## SERVICE INFORMATION LETTER

FROM: JetProp LLC

SUBJECT: Torque Transducer Line Drain Fittings

**Figure 1. Torque Transducer with Drain Fitting**

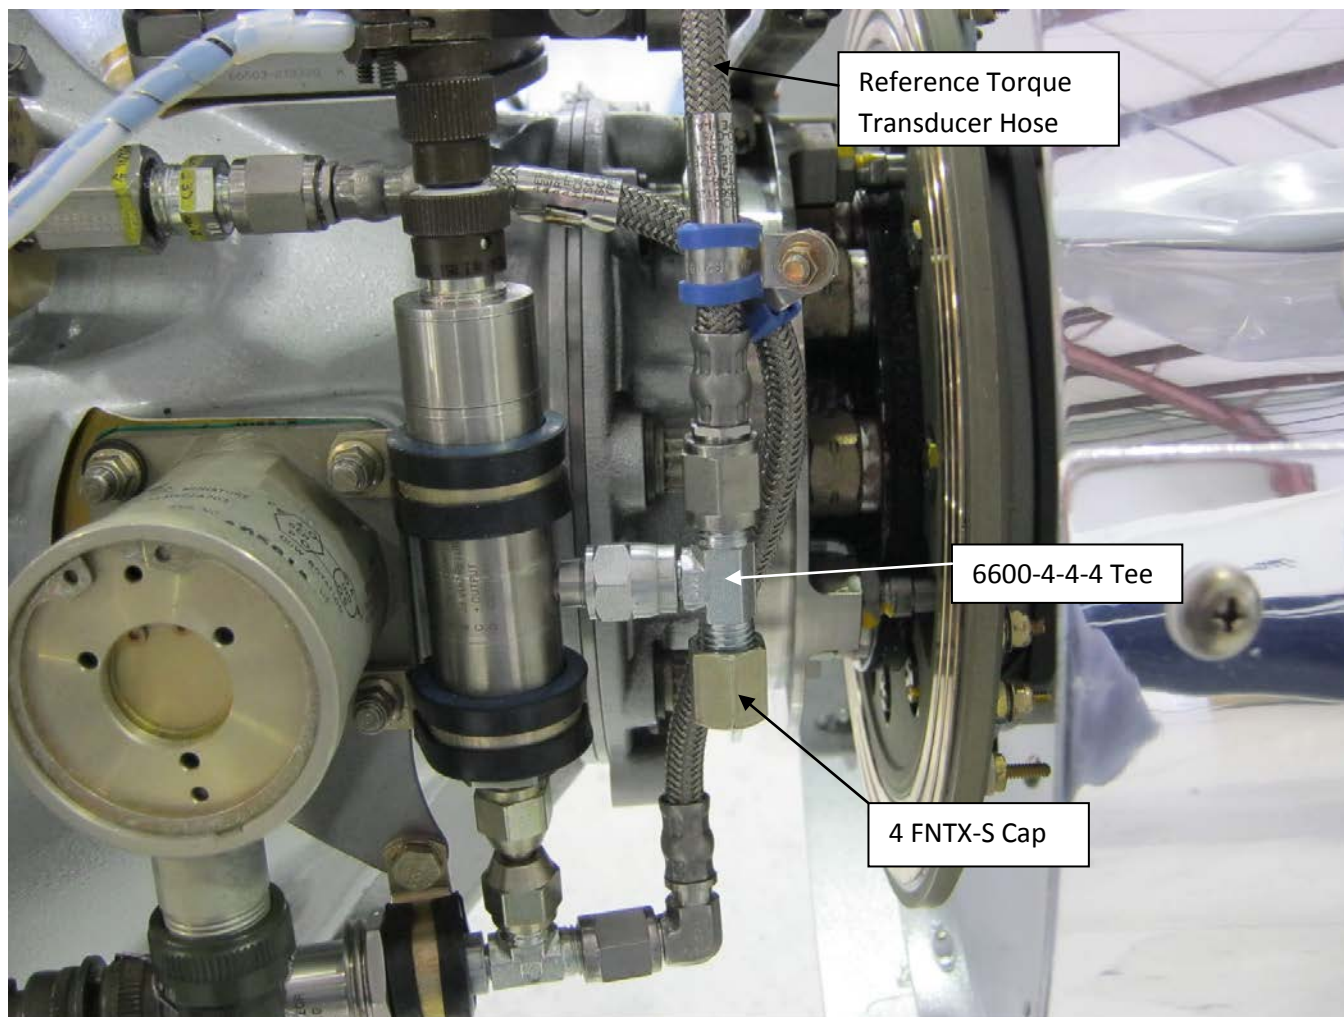
1. Overview. In an attempt to prevent the small amount of oil that gets into the torque reference line from causing a disruption of the reference pressure, two drain fittings have been added to collect the oil and aid in clearing the line. These fittings are shown in Figure 1 and Figure 2. The parts required for this upgrade are included in Table 3.

4. Install the 6600-4-4-4 tee on the torque transducer as shown in Figure 1.
5. Install the 6602-4-4-4 tee on the engine as shown in Figure 2.
6. Now, install the 90<sup>0</sup> end of the reference torque transducer hose removed earlier in step 3 to the tee just installed on the engine and as shown in Figure 2. Route the hose as before and attach the straight end of the hose to the tee attached to the torque transducer. Secure the line with the adell clamps as shown in Figures 1 & 2.
